Response to GMD-2016-47-RC2 (Sophie Valcke)

Figure 1: Time to solution of 5.0 and 4.8 COSMO-CLM versions in dependence on core number on Cray XC30 at CSCS, Lugano.

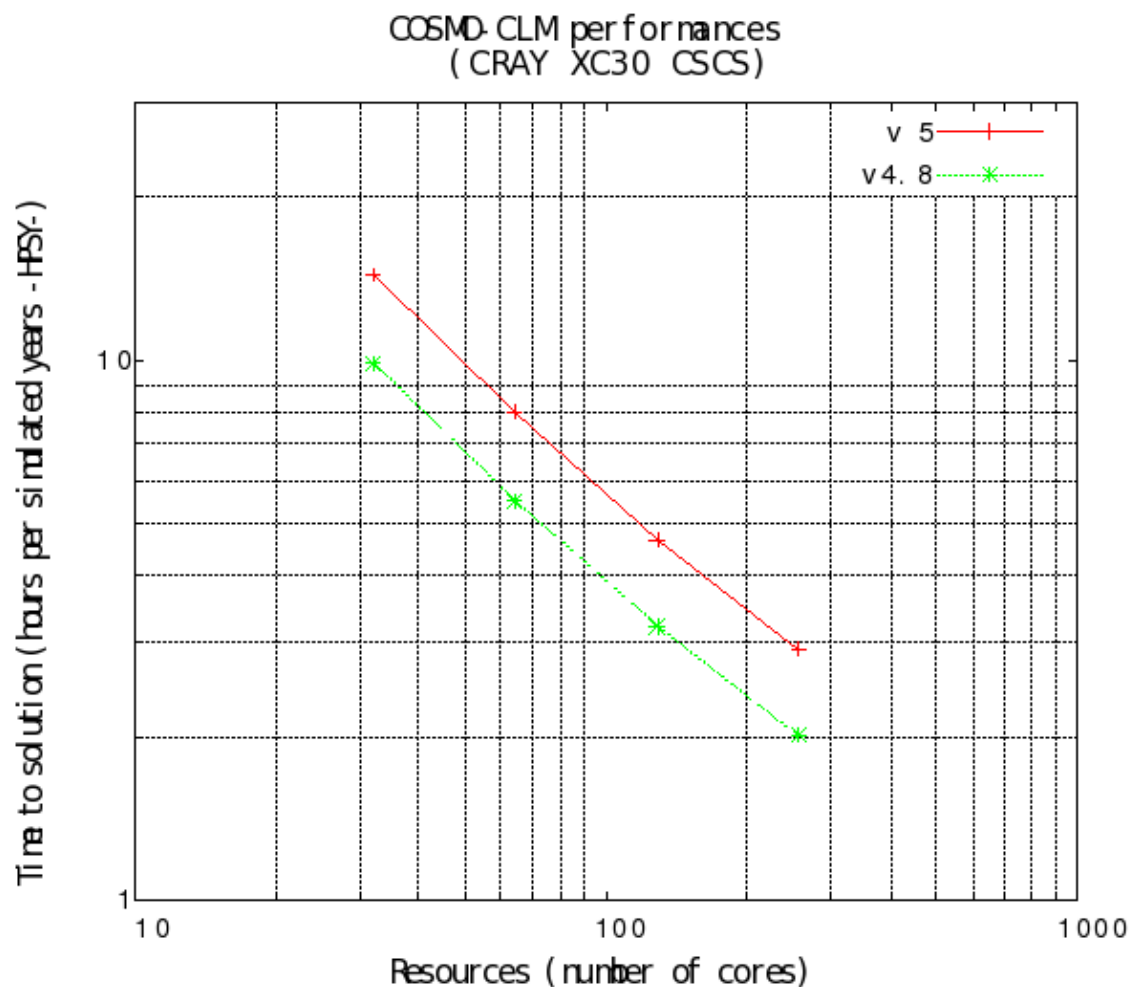
The fact that the COSMO version used for CCLM+CLM is different from the COSMO version used for CCLM+VEG3D and that the results presented for CCLM+VEG3D are in fact not the optimum ones (128 cores were chosen to be able to compare with CCLM-CLM) is disturbing and the paragraph p.25 l-843-855 is difficult to understand (same thing for p.27, l922-923). I am not sure on how to correct this but this should be simplified maybe simply by removing results for CCLM-CSM?

Answer: Thank you for the comment. We conducted additional measurements comparing cosmo_5.0_clm1 used in CCLM+CLM and cosmo_4.8_clm17 used in CCLM+VEG3D (on another machine since blizzard is not available anymore). This exhibited 45% higher cost of 5.0. We revised the result presentation and in particular this paragraph .

Answer: We thank the reviewer for this remark. We corrected section 2.6 accordingly.. “The model version cosmo_4.8_clm19 is the recommended version of the CLM-Community (Kotlarski et al., 2014) and it is used as basis of the development of the couplings. CCLM as part of the CCLM+CLM coupled system is used in a slightly different version (cosmo_5.0_clm1). The way this affects the performance results is presented in section 4.5, line 954 ff. In addition, the reviewer can see, in the figure below, a scalability comparison between the 2 versions. This reveals (even though the machine is not the same than the one used in the article) the cost of the 5.0 version are 45% higher than for 4.8.
